SPB Number: 2022.0301
EQUIPMENT-MILLWORK UPDATE

[X] All Travel Center Stores

Issued: 10/20/2022

STANDARD PLAN BULLETIN NOTICE
RaceTrac Engineering and Construction Division

Branch Panel: C

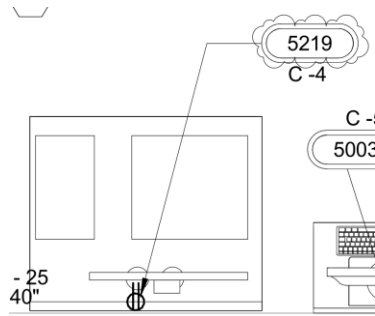
- PANEL C & C1 UPDATES:** Updated Panel C & C1 to be 30A Main and MCB ratings. Relocated security monitor #5041 (C-7) and BOH security monitor #5041 (C-14) to Panel E. Relocated Fax/printer from C-10 to C-16. Relocated Site camera fiber optics 2 from C-16 to C-14. Relocated coin safe #5001 from C-11 to C-17.

- Sheets: E110, E111, E430 & E431
- Attachments: E430

- Sheet: A100
- Attachments: A100

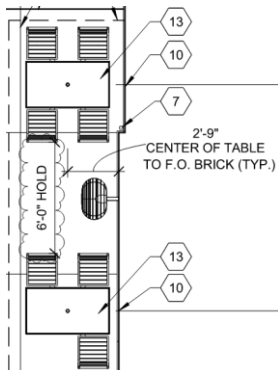
3. **PATIO TABLE SPACING:** Adjusted the spacing for the patio tables to be 6'-0" apart from each other.

- Sheet: A160
- Attachments: A160

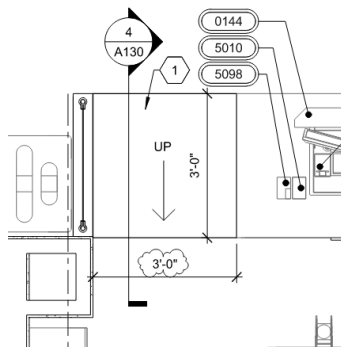
4. **RAMP AT CASHWRAP:** Adjusted the width of ramp at Cashwrap to be 3'-0" .

- Sheets: A140, A141, A502, A503, P002, P110, P120 & P410
- Attachments: A140

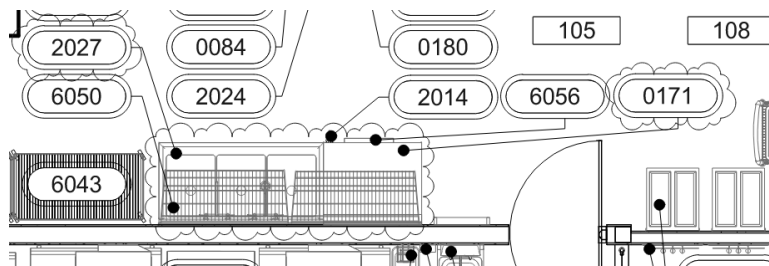
5. **THREE-COMPARTMENT SINK:** Replaced 3-Compartment Sink EQ. #2023 and Prep Table EQ. #0138 with 3-Compartment Sink EQ. #2027 and Prep Table EQ. #0171. Re-adjusted the Prep Table and 3-Compartment Sink location so the Prep Table is closer to the door.

- Sheets: E120 & E200
- Attachments: E120

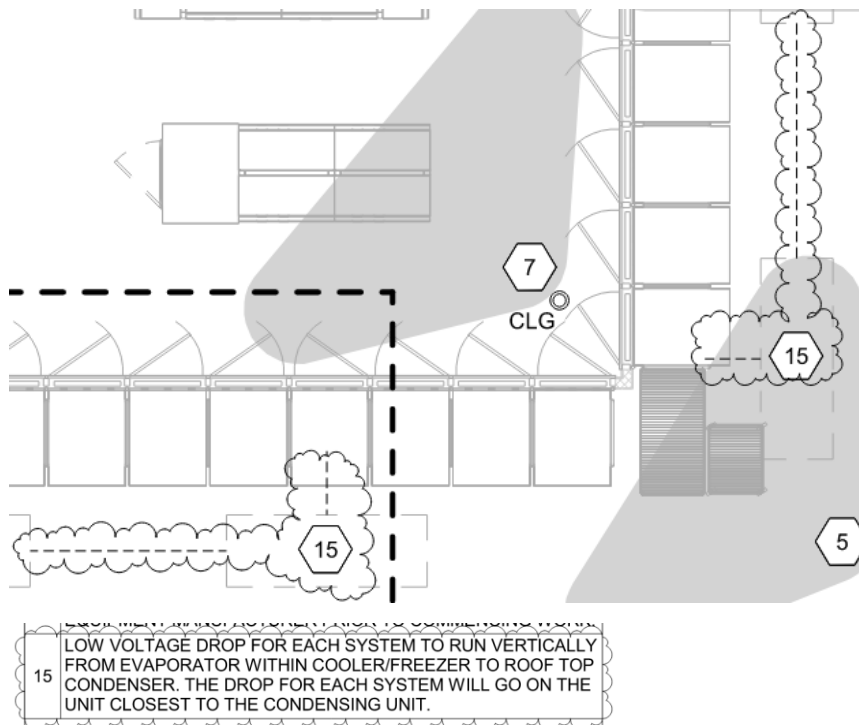
6. **CONDENSER-EVAPORATOR LOW VOLTAGE DROP:** Added keynote #15 on E120 and #7 on E200 indicating low voltage drop for each system to run vertically from evaporators within cooler/freezer to roof top condensers.

- Sheets: E110, E430, E431 & E432
- Attachments: E110

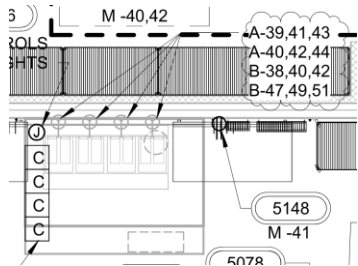
7. **FRYERS CIRCUITS:** Relocated the (4) fryer circuits from MDP. (2) were relocated to Panel B and (2) to Panel A. Relocated the (2) Non-Alch cooler condensers (A-39, 41, 43 & A-40, 42, 44) to MDP.

- Sheets: E110 & E430
- Attachments: E110

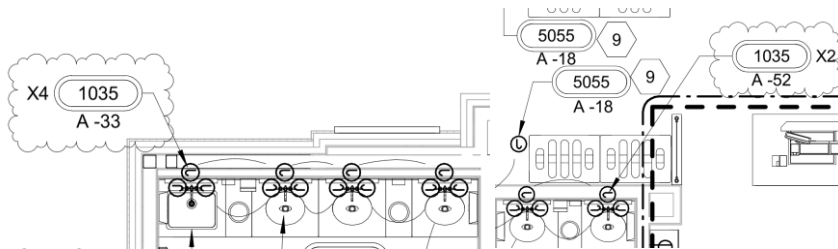
8. **MIRROR IN RESTROOMS:** Added power for the mirrors in both Men's and Women's restrooms.
